543 Church Street  
Apartment "C"  
Stair cross section Alt A

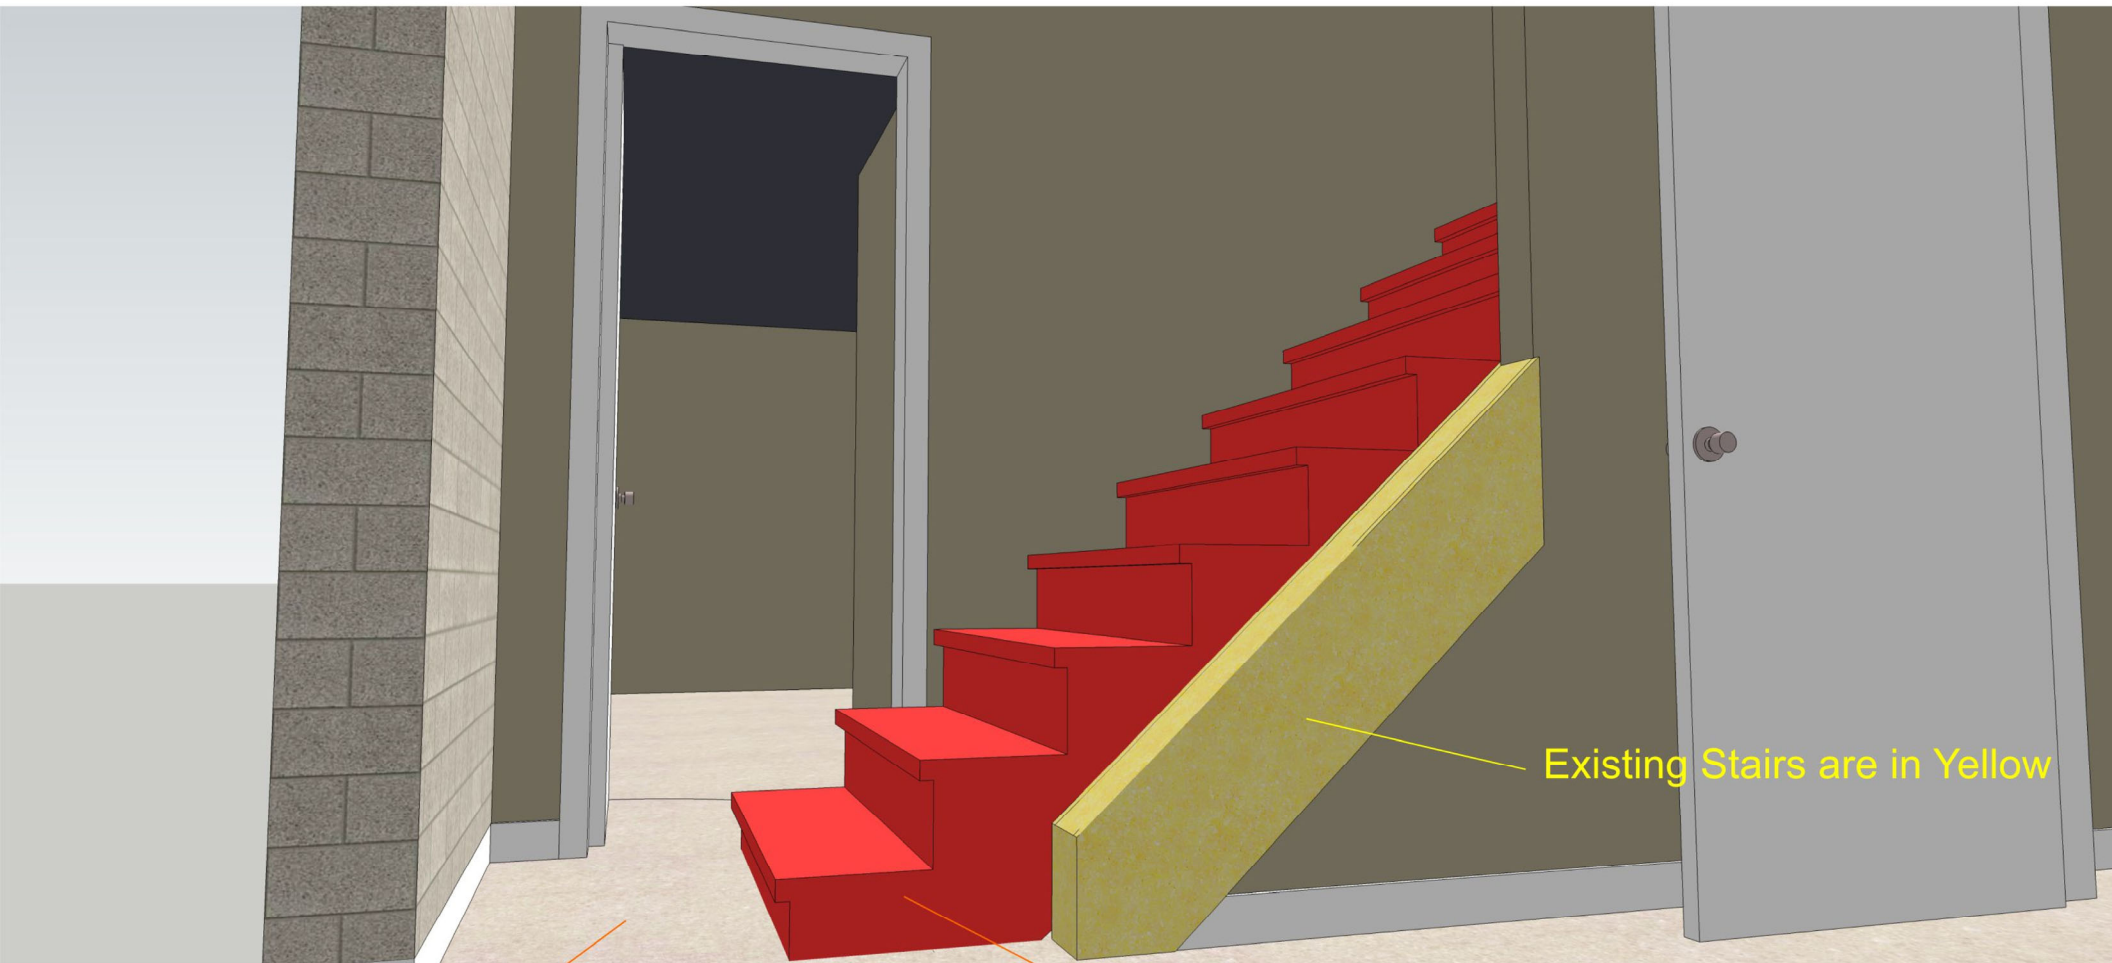
insufficient space  
for landing

Alternate commercial code stairs are in orange
